SEWAGE DISPOSAL SYSTEM

DEPARTMENT OF HEALTH AND MENTAL HYGIENE

P 50345

REPAIR - PURPOSE - DRAINFIELDS HAVE FAILED.

INDICATE NORTH - NAME ADJOINING ROADWAY AS BASE LINE

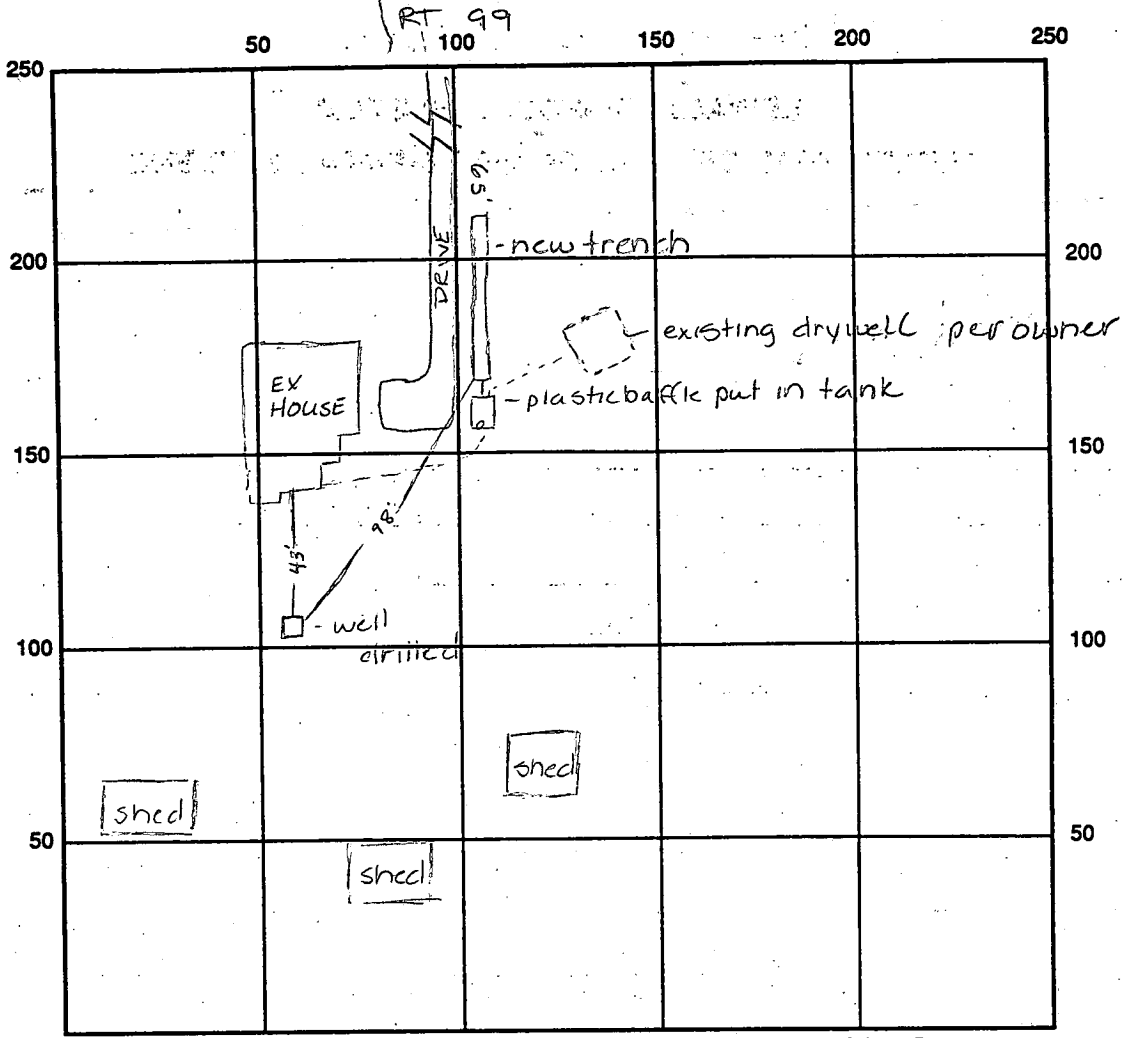
10-12-94 Dig trench 63' long w/ 12' of stone max bottom depth
of 11'. Run trench along existing driveway toward
RT 99.

REMARKS: 10-12-94 OK to cover all work final - materials on site
10' of trench left to fill w/ stone Auw
